Jacobsen Product Information Bulletin

Product Type: 4300 4 x 4 Tractor

Bulletin No: C-041-04

Kohler muffler

Figure 1

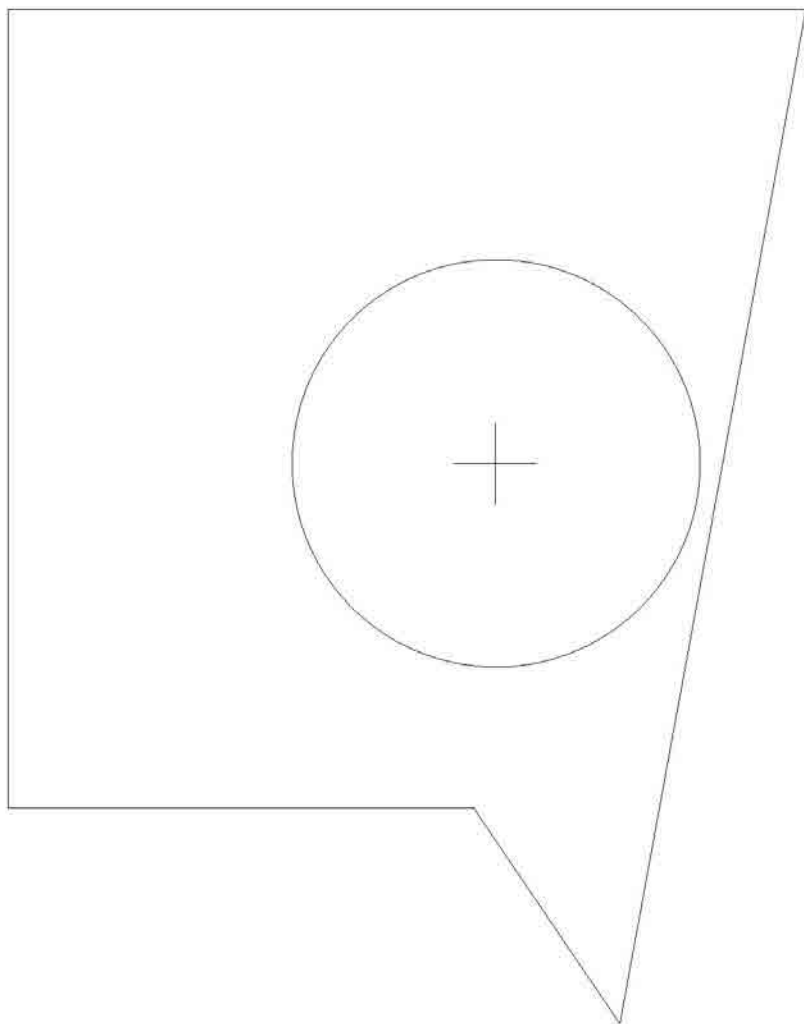
- 1) Order 4132729 muffler, 64205-013 M6-1 x 12 Bolt, 64006-01 ¼ " lock washer and 60-579.6 grille.
- 2) Order 4132729 muffler, 64205-013 M6-1 x 12 Bolt, 64006-01 ¼ " lock washer and use the template in figure 1, to add the hole in the grille for the exhaust tube.

Figure 2

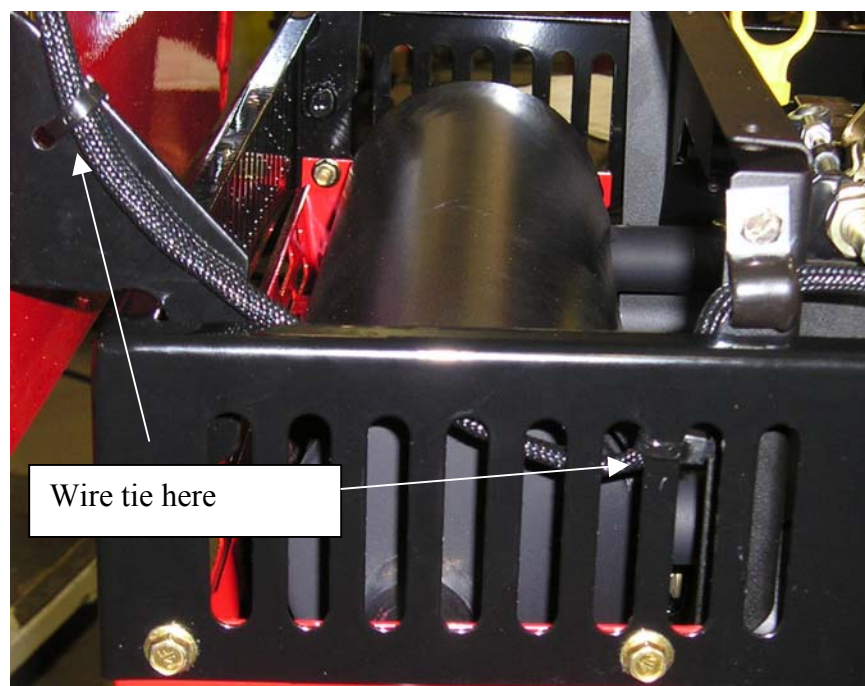
When muffler is installed, route the headlight wires as the picture shows in figure 2. You will also need to use quantity of 2 wire ties to keep the headlight wiring away from the muffler.
